# PERRY NUCLEAR POWER PLANT DEVIATION ANALYSIS REPORT

ITEM Ruskin Fire Dampers	LOCATION Perry Nuclear Power Plant	QUANTITY 85
ORIGINATOR <i>MAB</i> M. A. Brown <i>RLV</i> <i>WJK</i>	ORGANIZATION Construction Quality Engineering	DATE 8/8/80
RESPONSIBLE ORGANIZATION Ruskin Manufacturing Company	SPECIFICATION SP-49/91	REFERENCE DOCUMENTS See Attached

Subject: Ruskin's Vertical Spring Close IBD Fire Dampers

Subject: Vertical Spring Closure NIBD23 Fire Dampers

OWN. BY: T. LASHER DATE 1-14-80	CKD. BY: TA DATE 1-17-80	APP'V'D. BY: RVB DATE 1-14-80	CHANGE LETTER	REVISION DESCRIPTION	OWN. BY	APP'V'D. BY	DATE
				RUSKIN MFG. CO. P.O. Box 129 Grandview, Mo. 64030	SCALE 1/4"	ISSUE 1	
				TITLE VERT. NIB023 SPRING BRACKET MODIFICATION	DWG. NO. 5398

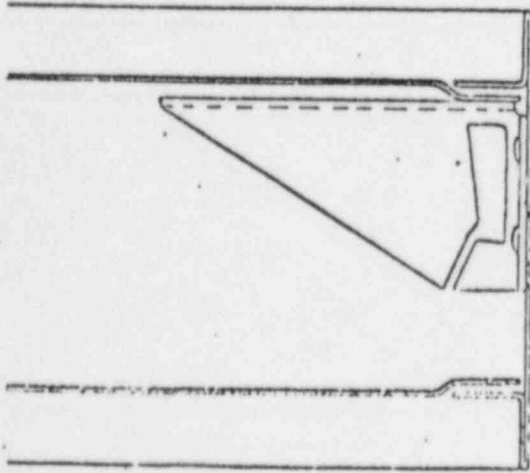
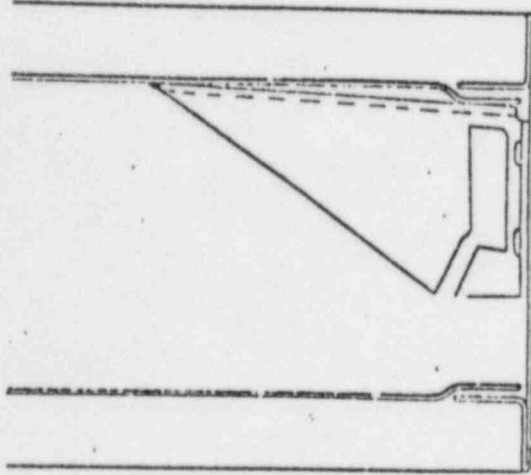
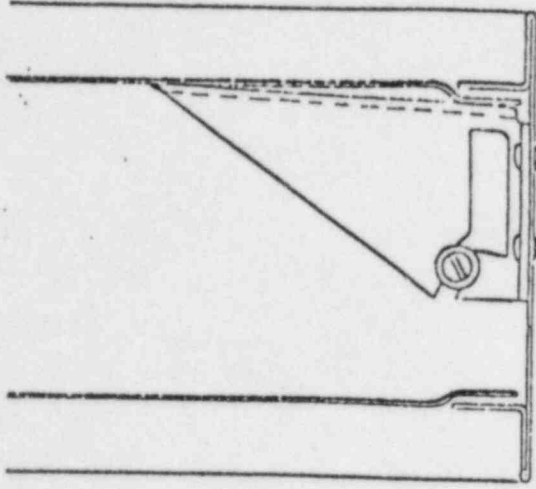
Vertical IBD type Fire Dampers with spring closure built by Ruskin after June 1979, have spring brackets installed with two rivets through the bottom of the frame and a tackweld holding the top of the bracket to the blade guide. Previous to this date, brackets had not been tackwelded to the blade guide. Addition of the tackweld came about after noting that repeated closings of the blade package during air test at our laboratory caused some bending in the brackets. Fastening of the bracket to the blade guide was to provide extra support for the bracket; however, it also alters the shape of the spring holding slot. This was discovered recently when we recieved a report from one job site of some springs coming out of brackets while the damper were being cycled. The engineering firm for this job has advised Ruskin that this problem is reportable under 10CFR part 21. Ruskin has reported it accordingly.

Ruskin, with the help and cooperation of the engineering firm for the project where this problem was discovered, has come up with a simple method for eliminating this problem. It consists of placing a #6 screw using a washer, star lockwasher and hex nut through the narrow portion of the spring slot (see drawing 5398 attached). This fix was successfully tested on a "worst case" damper at our laboratory, after duplicating the spring slipping problem.

ORIGINAL INSTALLATION  
(VERTICAL FIRE DAMPERS  
WITH SPRING CLOSURE)

TOP EDGE OF BRACKET  
TACKWELDED TO PROVIDE  
EXTRA SUPPORT FOR  
BRACKET & RESULTING  
ALTERATION OF SPRING  
SLOT

PROPOSED FIX - #6 SCREW,  
WASHER, STAR LOCKWASHER  
& HEX NUT TO KEEP  
SPRING FROM SLIPPING  
OUT OF SLOT

OWN BY: T. LARSEN	DESIGN TA	SCALE 3-27-80	REVISED BY: RUB	DATE 4-2-80	CHANGE LETTER	REVISION DESCRIPTION	OWN BY	DATE
RUSKIN Mfg. Co.					P. J. Box 128 Grandview, Mo. 64030		SCALE 20:15	
3-27-80					4-2-80		DATE NO. 2-6-84	
TITLE VERTICAL FIRE DAMPER BRACKET INDICATIONS					ISSUE 2-6-84

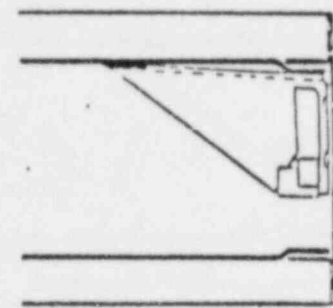
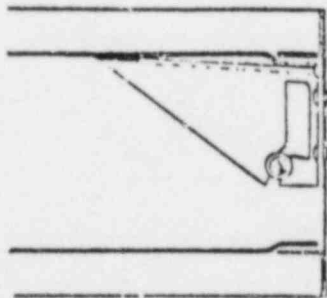
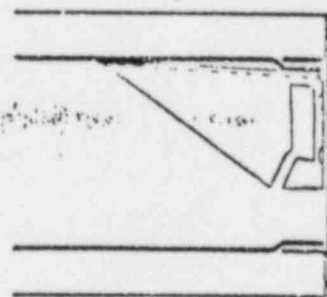
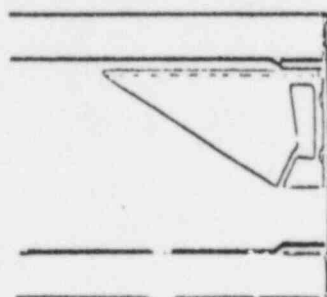
In our notice to you dated January 21, 1980, we addressed a problem relating to Ruskin's vertical, spring close, NIBD23 Fire Dampers and a fix or correction was suggested which consisted of fastening a #6 screw in the narrow portion of the slot in the spring brackets.

Although it appears that this method should have eliminated the problem, an engineering firm has indicated to us that some of the screws worked loose during shipment. This raises the possibility that the use of screws as a fix is questionable. We therefore request that you stop any activity relative to the installation of this fix.

ORIGINAL FIX USING  
#6 SCREW, WASHER, NUT  
LOCKWASHER & NUT

TOP EDGE OF BRACKET  
TACKWELDED TO PROVIDE  
EXTRA SUPPORT FOR  
BRACKET & RESULTING  
ALTERATION OF SPRING  
SLOT

ORIGINAL INSTALLATION  
(VERTICAL FIRE DAMPERS  
WITH SPRING CLOSURE)

Ruskin has now developed an alternate fix consisting of a small metal clamp which attaches to the spring bracket and provides a positive stop for the spring (see drawing 5564).

SPRING BRACKET  
BRACKET CLAMP  
INSTALLATION DETAIL

BRACKET WITH CLAMP  
INSTALLED

INSTALLATION OF  
PROPOSED BRACKET  
CLAMP (SEE DETAIL  
PAGE ALSO)

DATE 3-28-80 T. L. KASNER C.D. BY: T.A. P.D. BY: 208		FILE NO. 4-2-80 P.O. BOX 129 GRANDVIEW, MO. 64030		Dwg. No. 5 VERTICAL DIBOZ (9" NISH) AND LESS CLOSURE	
CHANGE LETTER REVISION DESCRIPTION Dwg. No. AS DATE		RUSKIN Mfg. Co. SCALE 1/8" = 1"

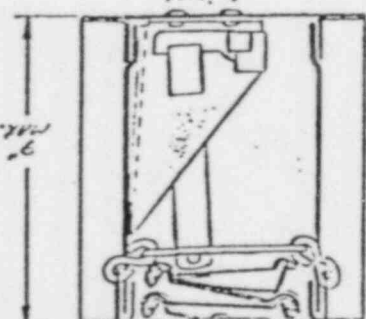
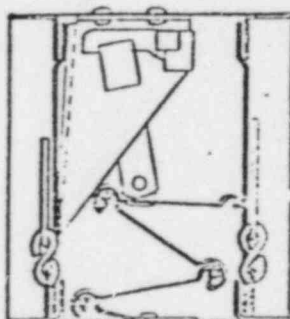
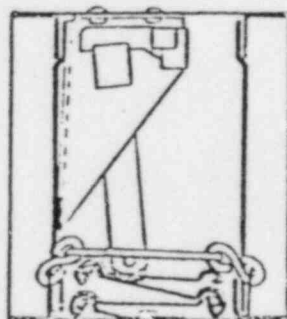
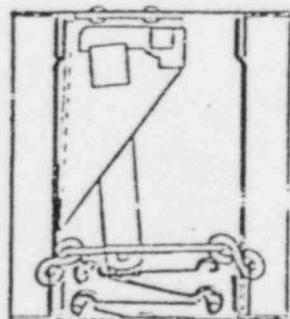
A second problem has also been brought to our attention. If the blade package in vertical units less than 9" high is shifted such that the leading edge of the bottom blade rests higher than the trailing edge, the blades may jam when released.

ABOVE THE GLASS PICKUP  
HAS BEEN SHIFTED PLACED  
THE LEADING EDGE OF  
THE BOTTOM BLADE TO BE  
ABOVE THE TRAILING  
EDGE - IF THE FUSE  
LINK MELTS WITH THE  
BLADES IN THIS POSITION,  
THEY WILL JAM AS IN  
THE NEXT DETAIL

BLADE PICKUP JAMMED

Ruskin has developed a snap-in strip which when installed will hold the bottom blade in the proper orientation and insure complete and consistent closure (see drawing 5565).

VERTICAL DIBOZ  
AS SHOWN, THE ORIFER  
WILL CLOSE COMPLETELY  
AND CONSISTENTLY WHEN  
THE FUSE LINK MELTS

CAMPER WITH SLIP IN  
STRIP (SHOWN AT RIGHT)  
INSTALLED, SIDE LEADING  
EDGE IS HELD BELOW  
TRAILING EDGE OF BOTTOM  
BLADE, UNIT CLOSSES  
COMPLETELY & CONSISTENTLY

3/8" x 1/8" x 1/8" ST. STEEL

9" MAX.
